Hillsborough Street Door Zone Bike Lane, Raleigh NC

Wayne Pein
August 2010

Summary

Cambridge BL + Typical SUVs

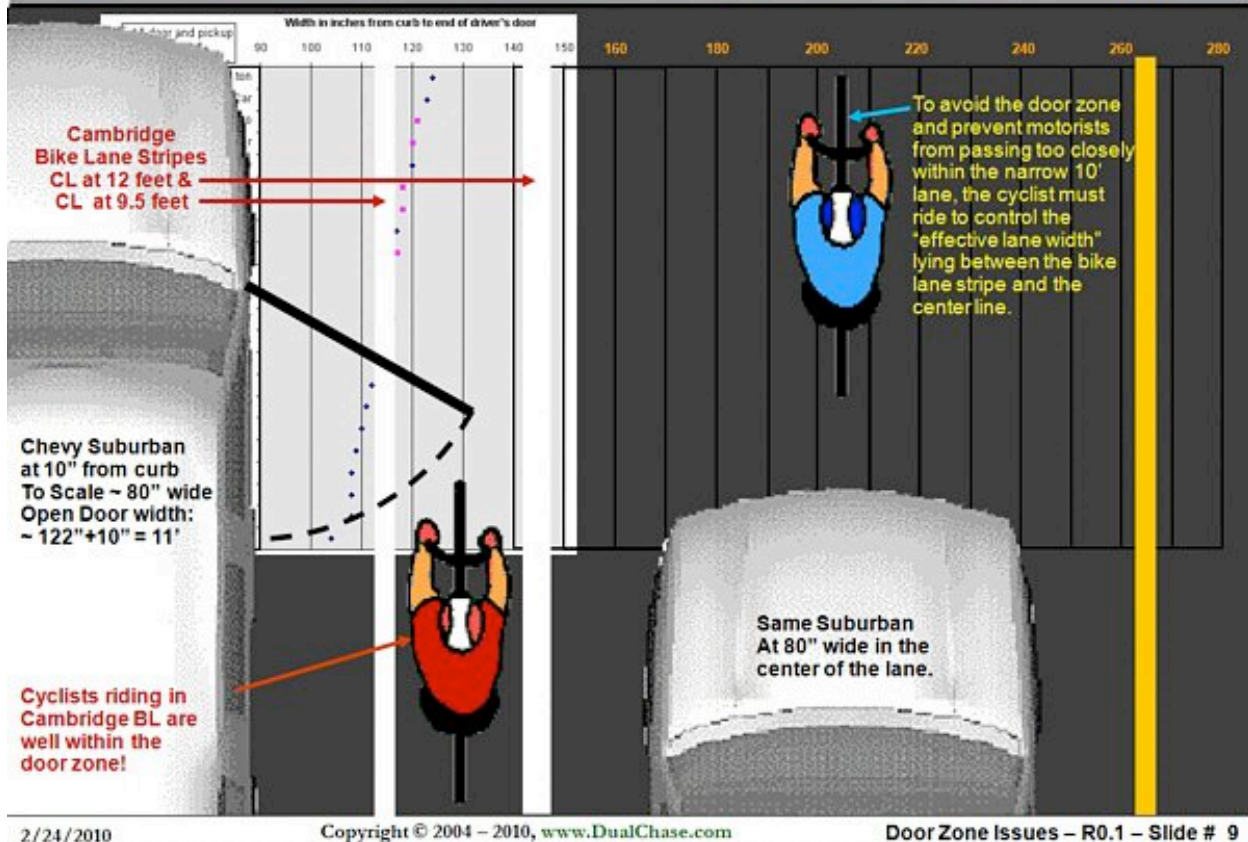
In this drawing of a Cambridge, MA bike lane showing actual dimensions, a vehicle parked 10" from curb face has an open door width of 11'. This door would extend to the middle of the proposed Hillsborough Street bike lane, putting bicyclists at grave risk of a door strike. The dots in the white area depict the open door widths of other measured vehicles.

Further, because the proposed general travel lane on Hillsborough Street is a narrow, substandard 10' (heavy trucks and buses are 8.5' wide not including extended mirrors), the close spacing creates a danger to bicycle users who may deflect off an opening door or be startled into swerving left. The raised median also constrains motorists from adjusting left.

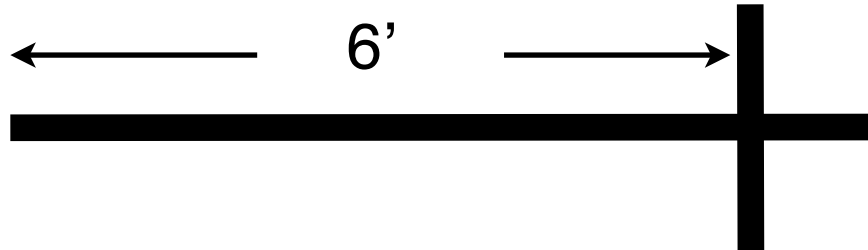
In this diagram, the designers recognized that a 5' buffer is required for travel safe from the opening doors of parked vehicles. There is one line of traffic.

However, in the proposed cross section with 4' Bike Lane, only an inadequate 2' buffer is specified. A second line of traffic --bicycle-- is added. Opened doors from parked vehicles will extend into the bike lane by as much as 2'.

The North Carolina *Guidelines* assume a bike lane next to the curb with full clear space, and prudently maintain that 16' of total space is the **minimum** for a bike lane plus the adjacent standard lane. On Hillsborough Street the proposed substandard 10' "travel lane" with a 4' bike lane is a total of just 14'. Worse, the bike lane is not even a minimum 4' of clear space: car doors will suddenly and unexpected extend into the bike lane by as much as 2'.

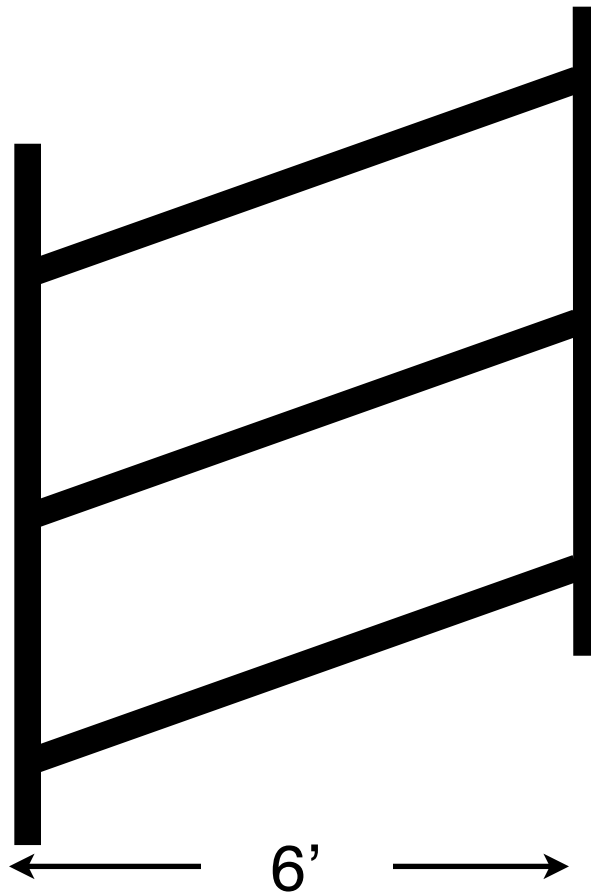
Do not place bike lanes. Parking stall “Tees” with 6’ extensions or cross-hatched diagonal lines can effectively visually cue bicycle and other drivers to the door swing area to be avoided.

Optional treatment to place the R4-11 sign in the median.

Place the Shared Use Marking 17' on-center from the curb face.
